STAFF RECOMMENDATION
144 Windsor Drive
April 19, 2017

Metropolitan Historic Zoning Commission
Sunnyside in Sevier Park
3000 Granny White Pike
Nashville, Tennessee 37204
Telephone: (615) 862-7970
Fax: (615) 862-7974

Application: New construction—addition violation
District: Belle Meade Links Triangle Neighborhood Conservation Zoning Overlay
Council District: 23
Map and Parcel Number: 13001008600
Applicant: Jackie Daniel, Owner
Project Lead: Sean Alexander, sean.alexander@nashville.gov

Figure 2: The solid box above shows the general height of the green wall, as seen from the rear. The chimney on the far left was not constructed.

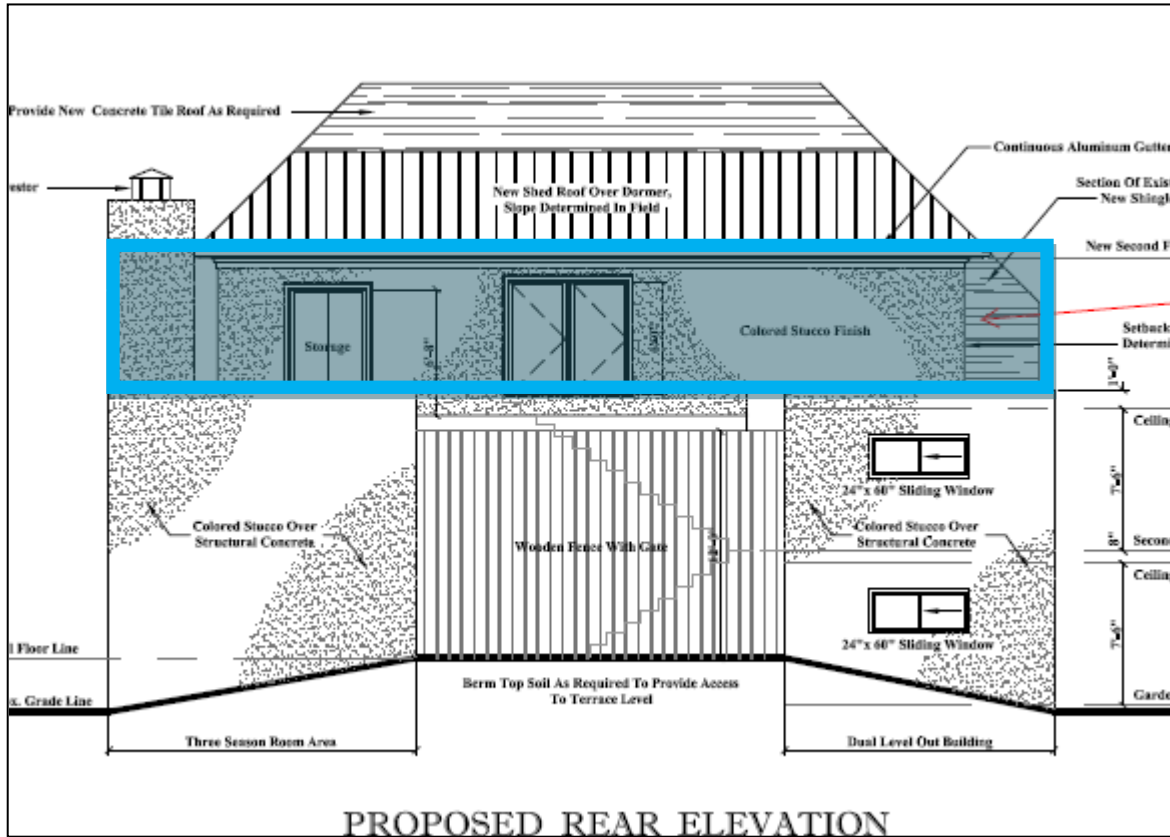
Height, Scale & Setback: The height of the one-story existing addition is approximately seventeen feet (17') tall at its tallest point, compared to the approximately thirty-two (32') foot tall existing one and one-half story building. The addition will now appear to have a twenty-five foot (25') tall rear wall and twenty-one (21') tall side walls. The rear wall will just barely exceed the eave height of the rear dormer (see figure 2) and the side walls will be below the eave height (see figure 3). Although the original building is considered 1.5 stories tall, because the second level is fully under roof, the roof is much taller than the typical half-story of historic buildings in the neighborhood; therefore staff

considered the building as more of a two-story building and used the rear dormer eave as the basis for an eave height for the building.

Staff is concerned that the height of the wall of the 2011 addition was already too tall at seventeen feet (17'), especially for an addition that exceeds rear and side setbacks,

Figure 3: The solid box above shows the general height of the green wall, as seen from the side.

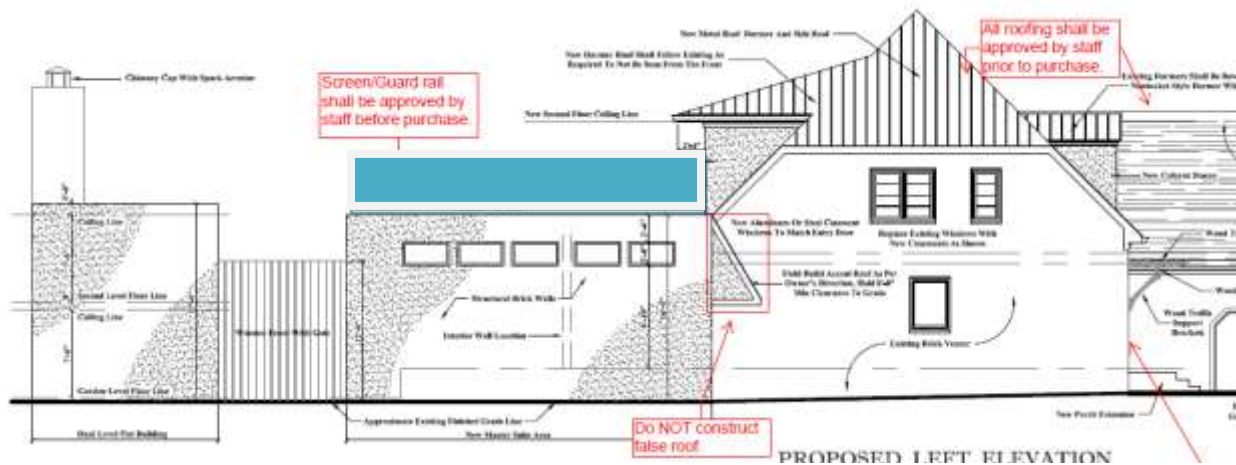
exceeds the typical open space area of the district, and that does not have a rear alley to serve as a buffer. However, the property backs up to an area that is not in the neighborhood conservation overlay and includes a new home that is significantly taller than any homes in the area. The addition is more likely to negatively affect side neighbors but the addition adds only four feet (4') to the existing wall. (See figure 3.)

Staff's greatest concern is that a similar wall may be proposed for the many rooftop decks the Commission has approved in recent years. Staff suggests this one is appropriate only because the building is non-contributing, the proposed wall only minimally exceeds the existing eave height on the rear and is well below on the sides, and the property backs-up to an area outside of the overlay. Staff finds the project to meet sections II.B.1 a and b.

2011 approved site plan, shows the left wall slightly over the side property line and a rear setback of 10'.

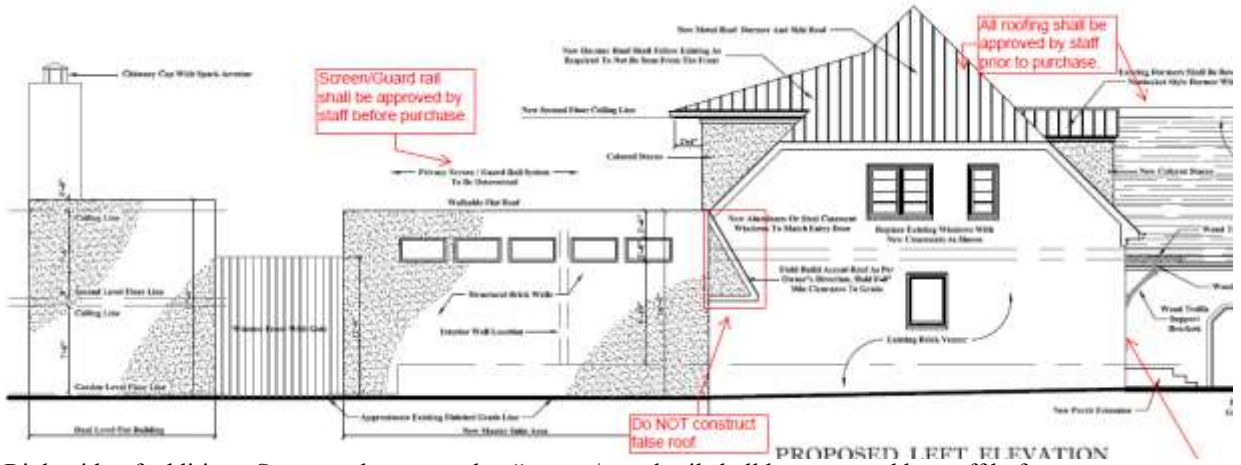
Right side of addition. See note that states that “screen/guard rail shall be approved by staff before purchase.”
